27 September 2022
File No. 0127981-026

Subject: Approval "as-modified"
Interim Remedial Measure Work Plan
IRM-7 Buried Received Tube Waste
Philips Lighting Company Bath Facility
7256 State Route 54
Bath, New York
BCP Site #C851044

**FIGURE 4
IRM-7 IMPLEMENTATION SCHEDULE**

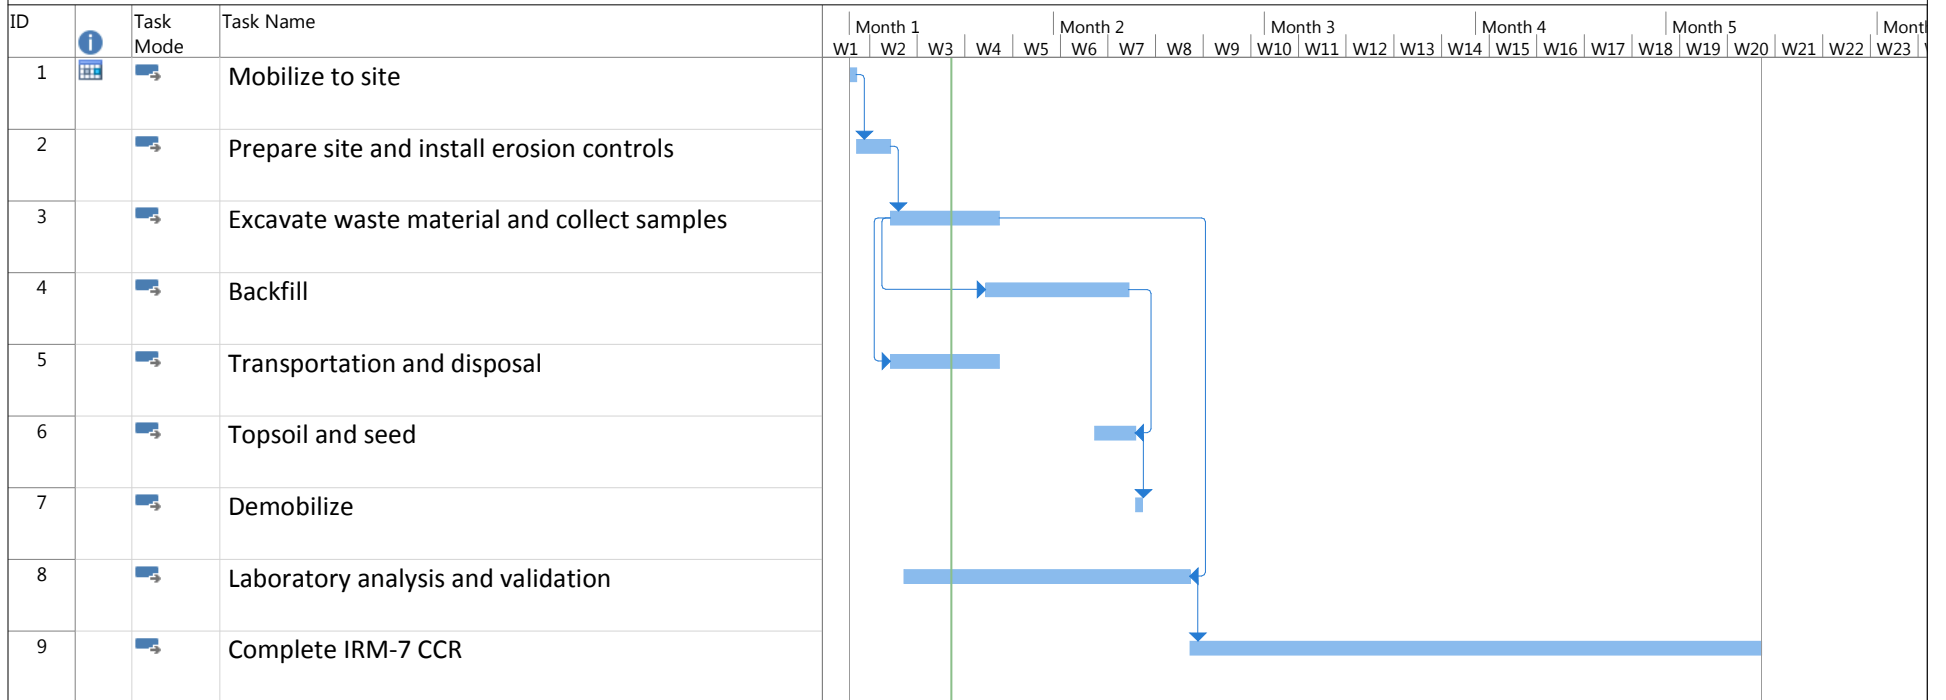
NYSDEC has requested a calendar schedule for the IRM-7 activities. The project implementation schedule included as Figure 4 in the IRM-7 Work Plan (attached) describes the anticipated sequence and duration of IRM activities, but not specific start/completion dates. The actual start of the work is contingent upon a number of factors including demolition sequencing and other complementary remedial measures. Once the schedule for implementation of IRM-7 has been determined, an updated schedule/sequencing will be provided, and the NYSDEC will be notified at least 7-days prior to commencement of field activities.
